**VALUE ENGINEERING SUMMARY
OF
I-75 WIDENING
BETWEEN KY 192 AND KY 80
LAUREL COUNTY, KENTUCKY**

APRIL 13-17, 1998

EXECUTIVE SUMMARY

V. E. 2 Alternative I-75

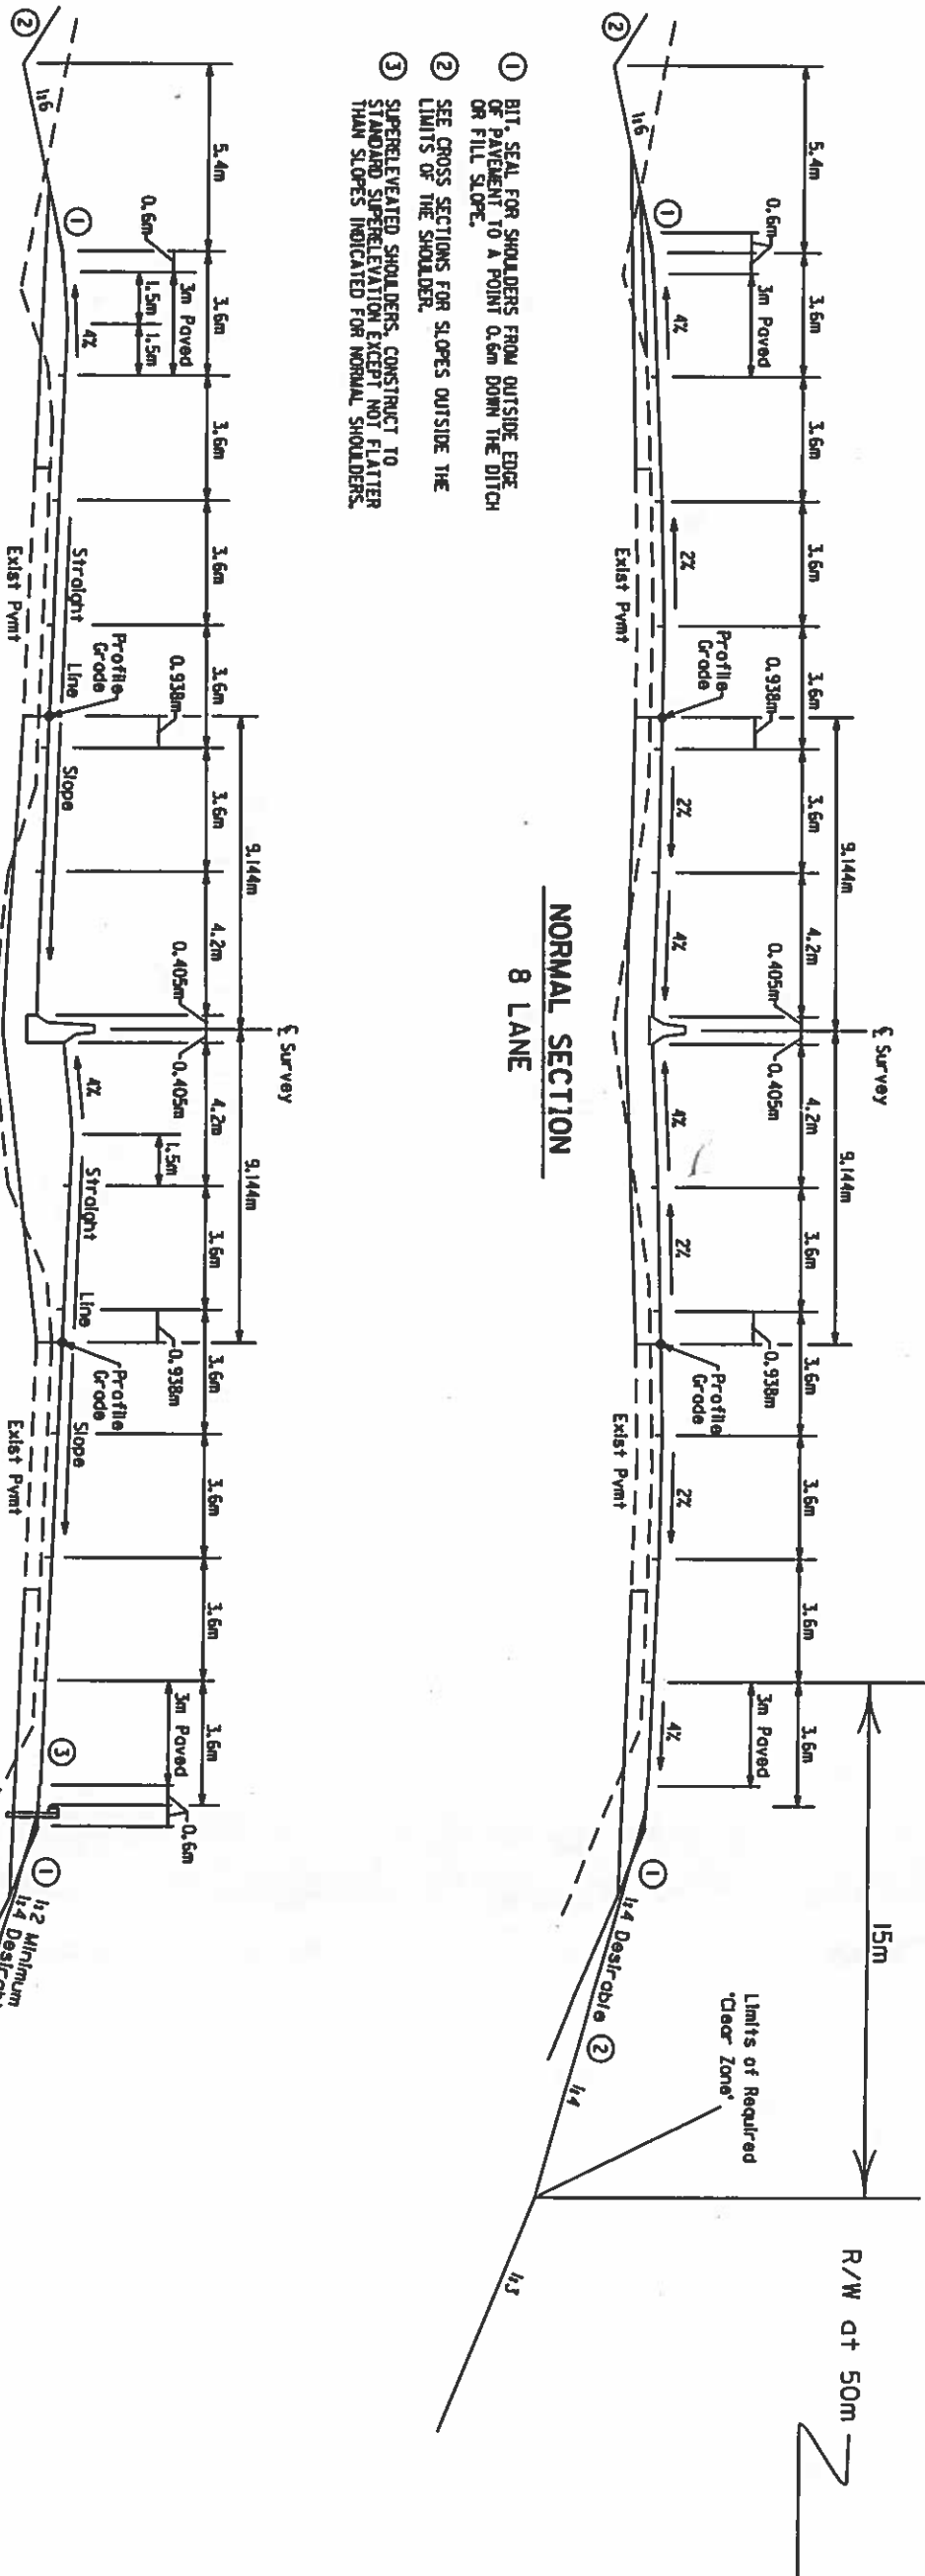
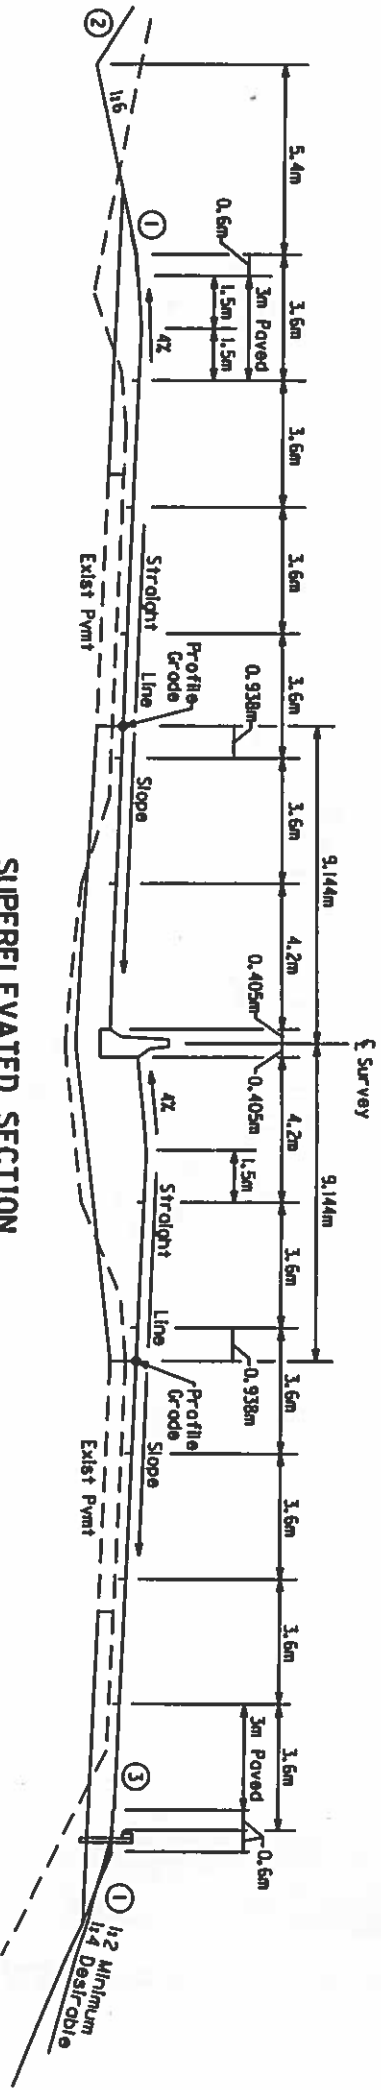
The Value Engineering Proposal Number 2 recommends flattening the embankment to the desired slope of 4:1 with the limits of the clear zone. This proposal would eliminate the need for guardrail and minimizes the waste material to be hauled off the job. Based upon the available cross sections, this alternate can be performed at seven different locations without the need for any additional right of way.

See Exhibits
PCMB 1 and
PCMB 2 for more
detailed drawings
of The 355C1
wall.

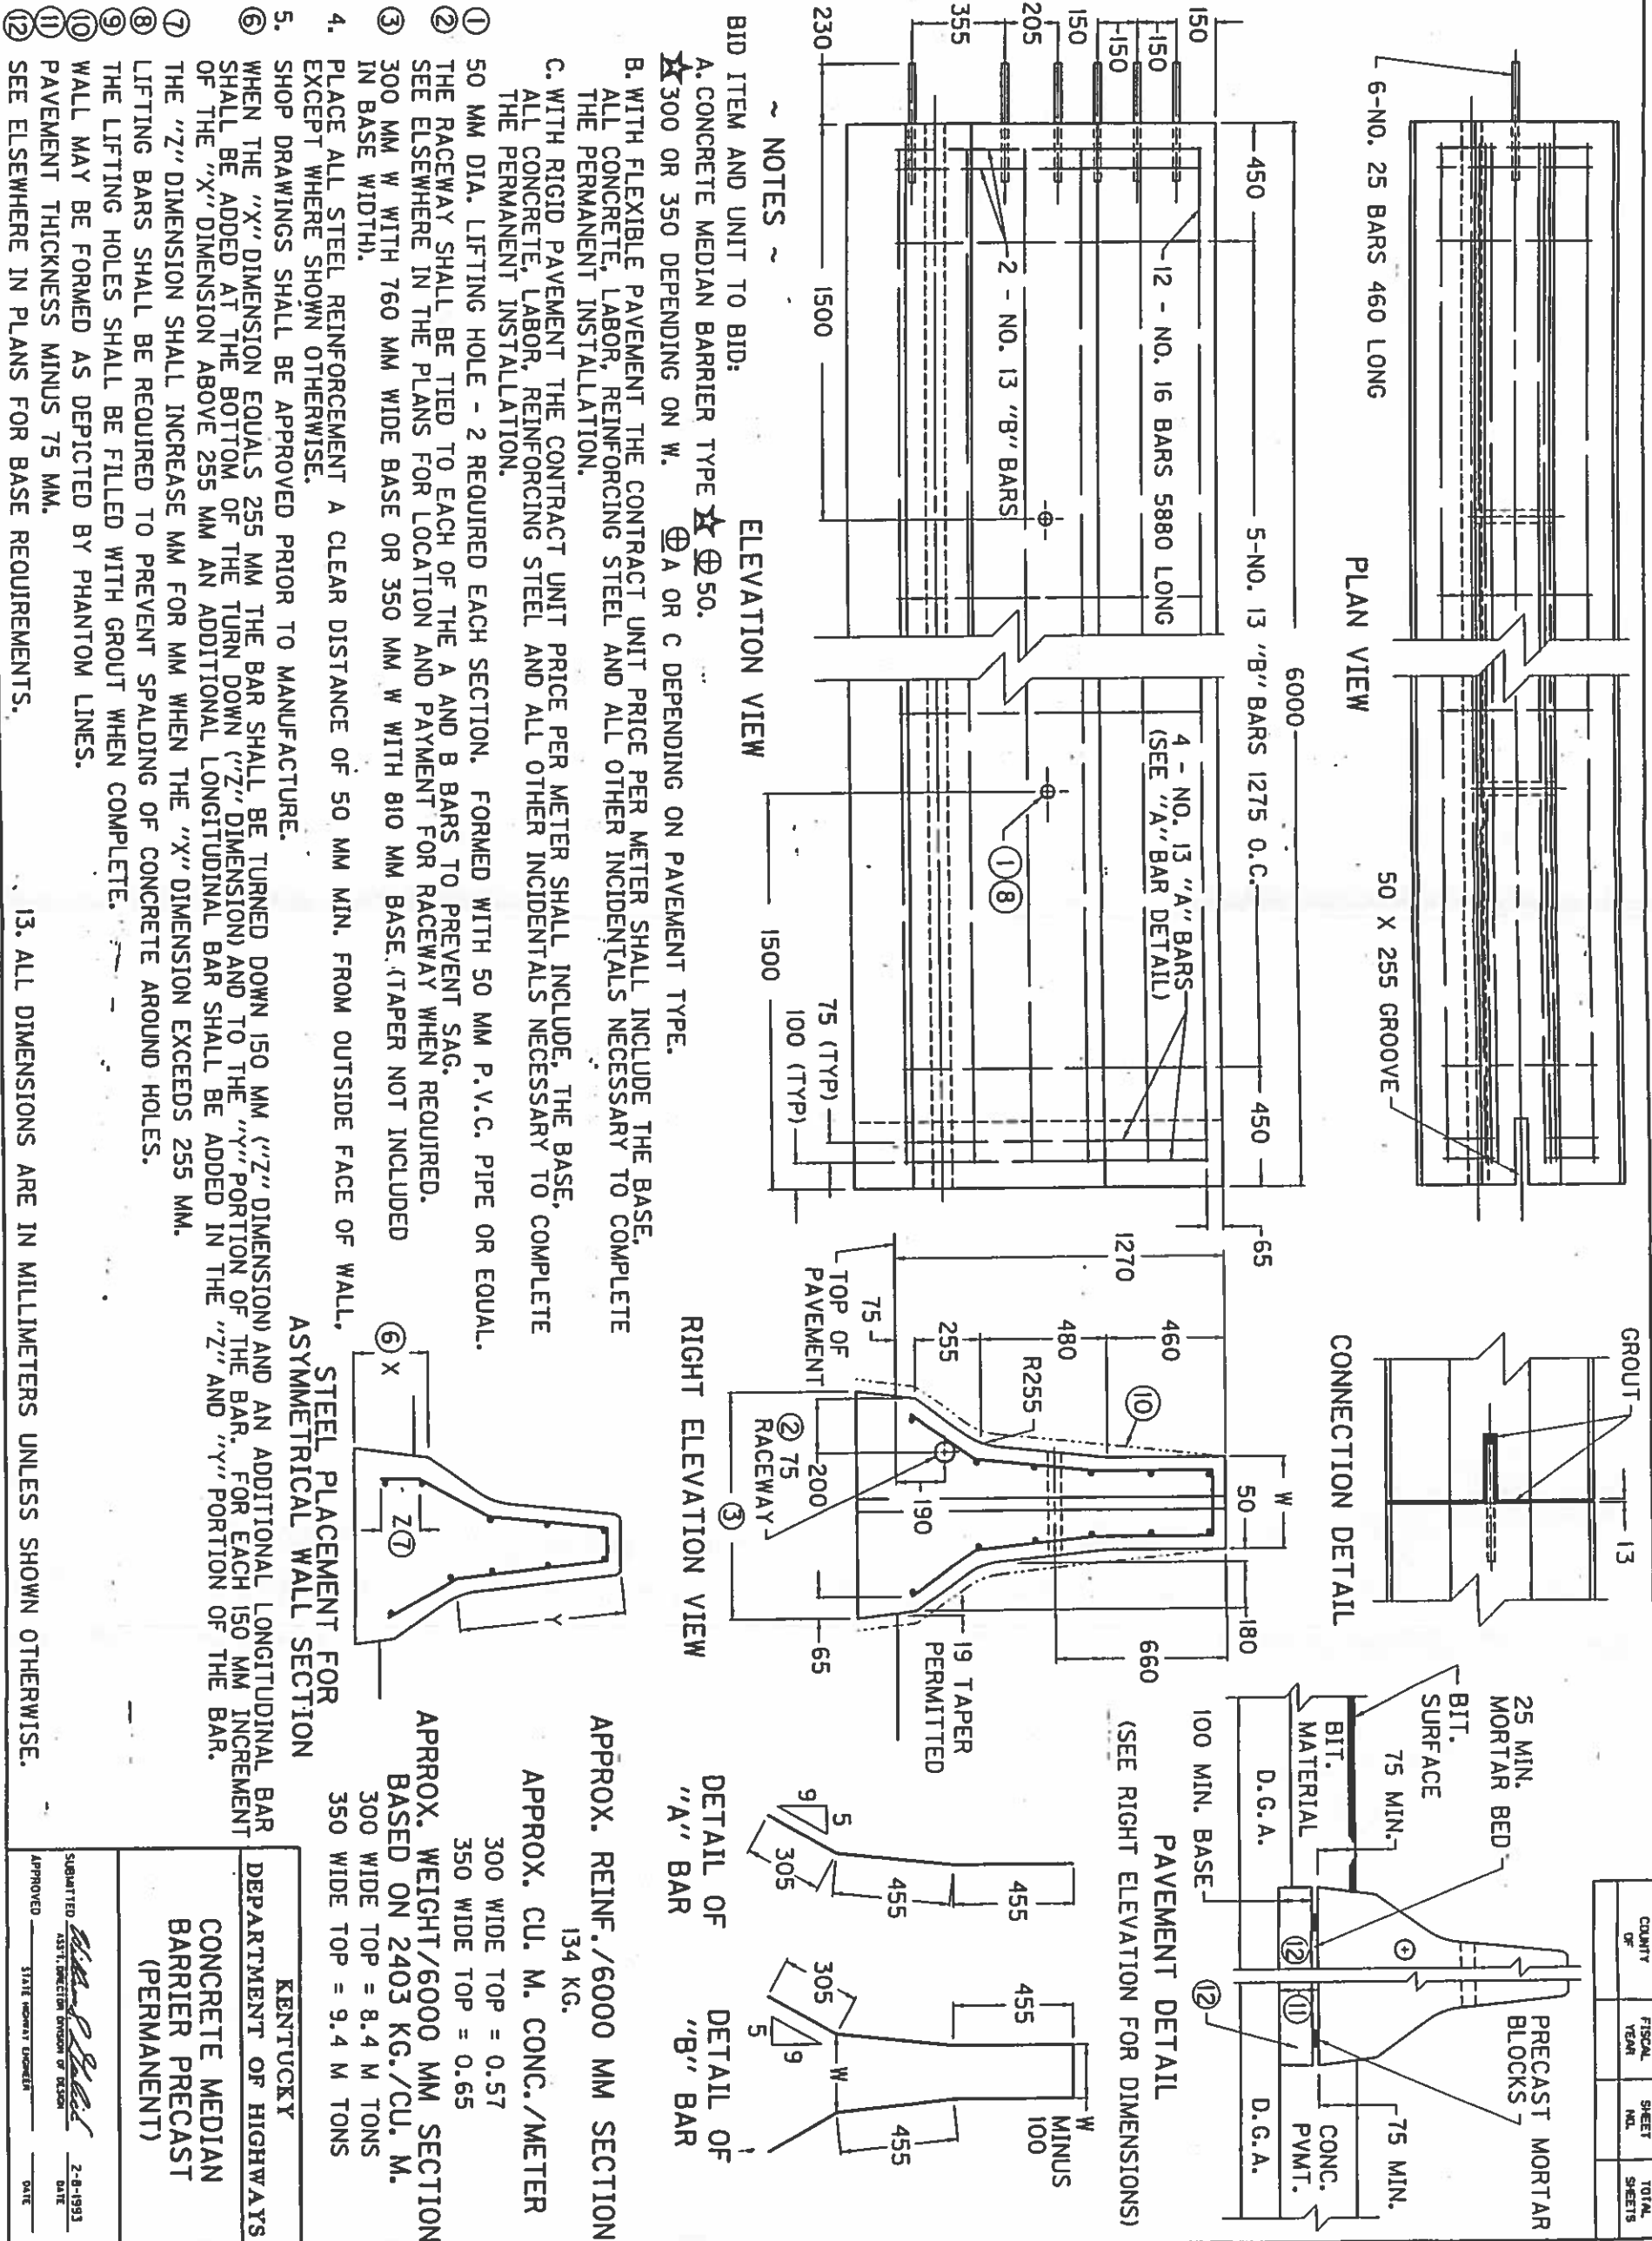
Designed feature is New Jersey shape Concrete Barrier wall w/ extra height to provide headlight glare protection. Designated as Type 355C1, it is 355mm wide at the top and the base height is suitable for bit, surface application.

Along the increased height from 815mm to 1270mm does provide glare protection from the 3.5' (1070mm) driver's eye height, we do not feel it is warranted for this project. It is our understanding that no study was done on this and it was implemented by preference only. We propose to do several things:

Use standard barrier wall except in areas of superelevated sections.

As previously detailed, there is no advantage to using a wall with the increased height and thickness. In addition, savings can be found by utilizing the Temporary Barrier section as part of

RECOMMENDED ALTERNATIVE -
- SKETCH AND DESCRIPTION

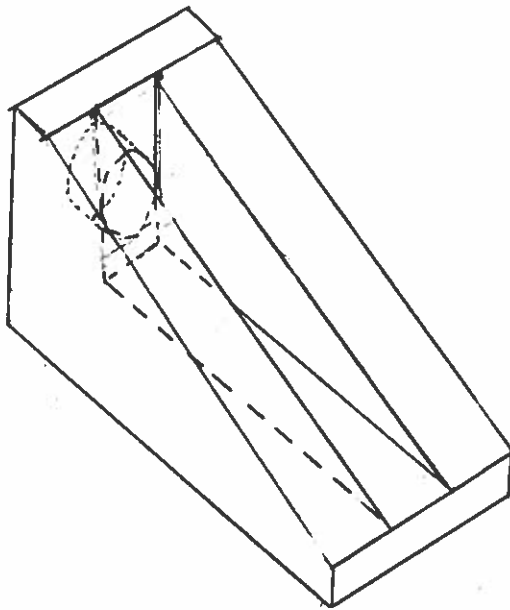
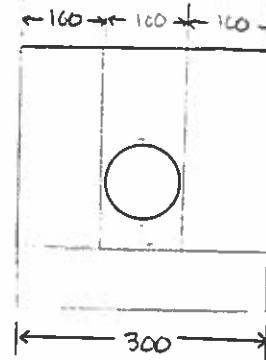
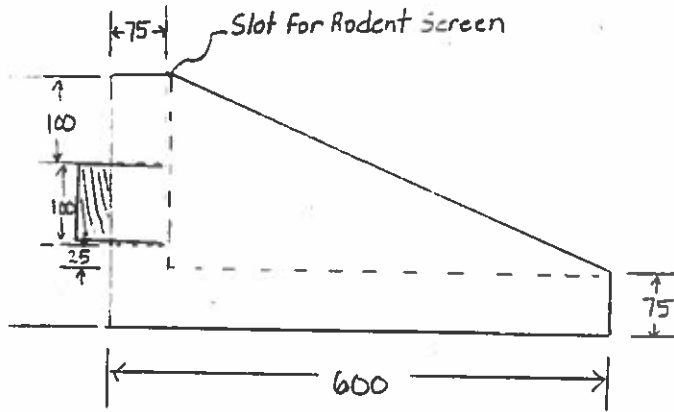
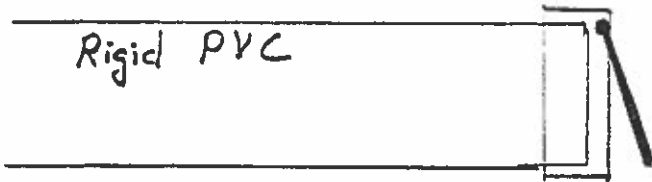
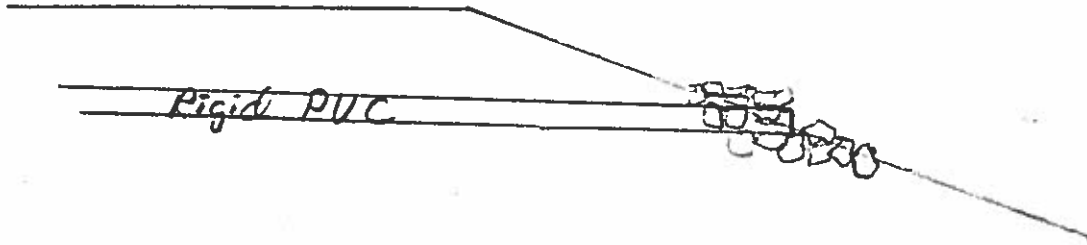
Rock will replace the Headwall and a Rodent Cap will keep the pipe clean.

Will Fit 2:1 or 3:1 slopes.
